BARAKA FASHIONS LIMITED (Extension)

6 Shing Bari Road Boro Dewra Tongi, Gazipur-1700.

13 March 2023

Store Building: This structure is a six storied (G+5) reinforced concrete (RC) building.

Internal column stressed above normal design limit

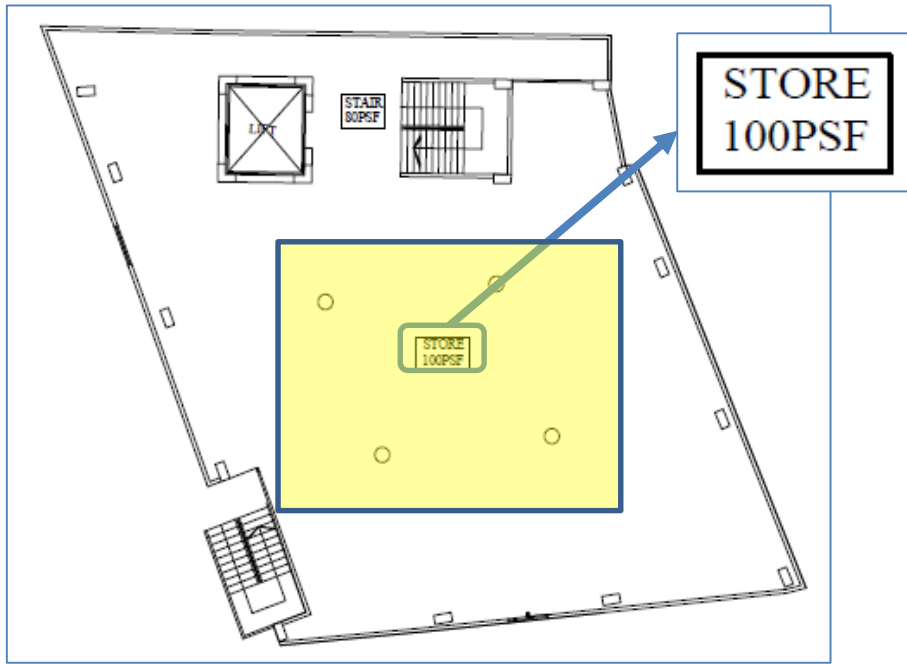
The cursory calculation indicates that internal columns stress exceeds the normal design limit considering a typical floor live load 6 kPa, and minimum concrete strength 16.3 MPa based on aggregate type. The building engineer is required to review the design, loads, and column stresses.

**Load plan & design report not comply
with BNBC requirements**

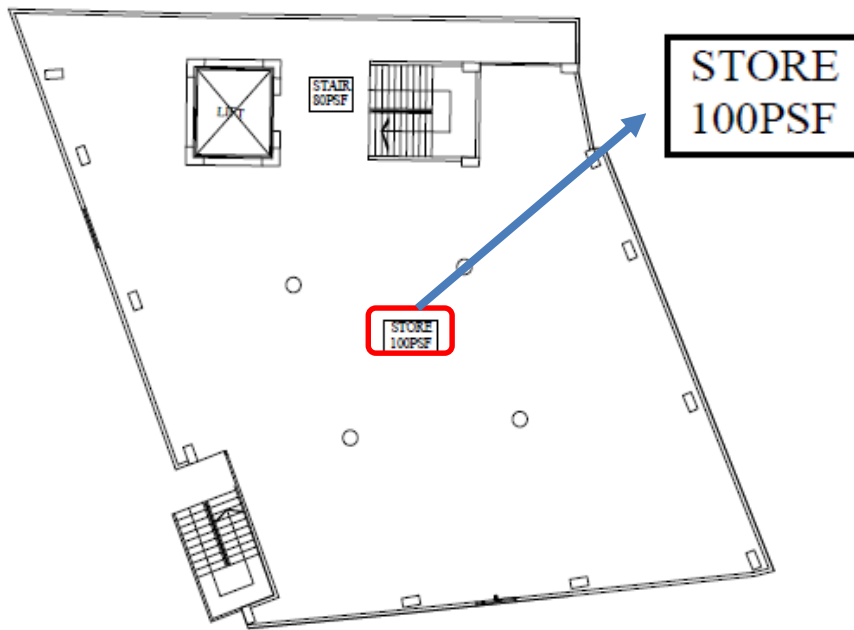
Currently, the typical floor of the building is being allotted for fabric store. As per BNBC, the minimum floor live load for light storage is 6 kN/m² (125 psf). But the storage (typical floors) area of the building is designed for 5 kN/m² live loads. The building engineer is required to revise the storage live load limit and related design documents based on BNBC requirement.

Corrosion on exposed rebar

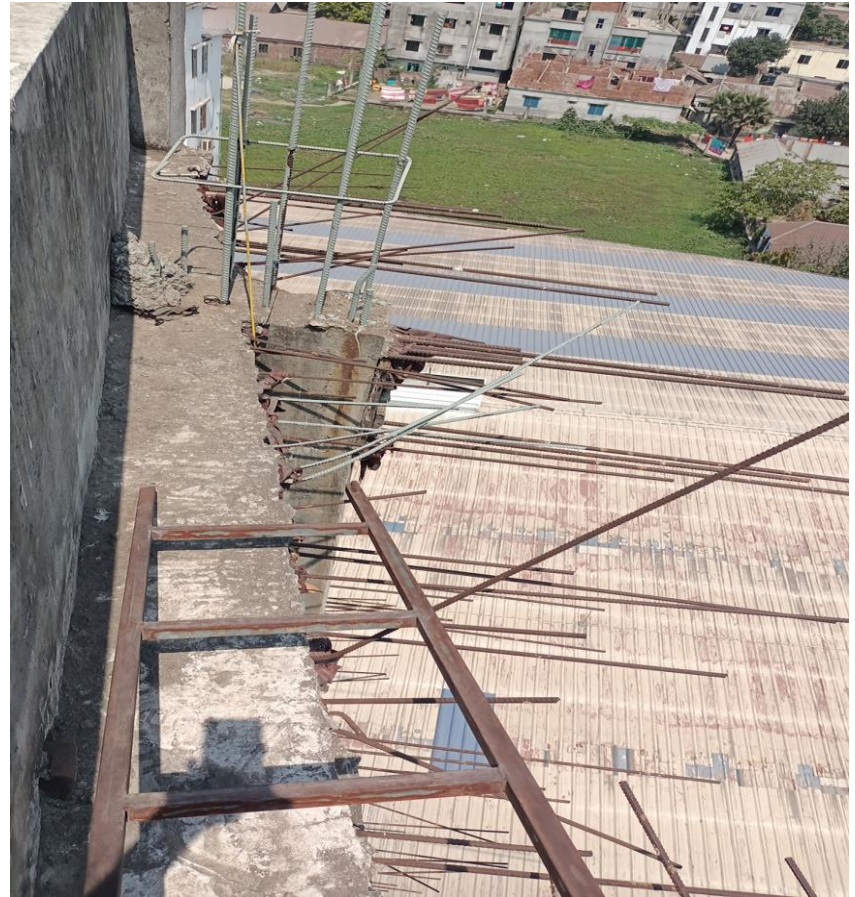
Corrosion observed at exposed rebar. Building engineer is required to take proper measure to protect the rebar from corrosion.
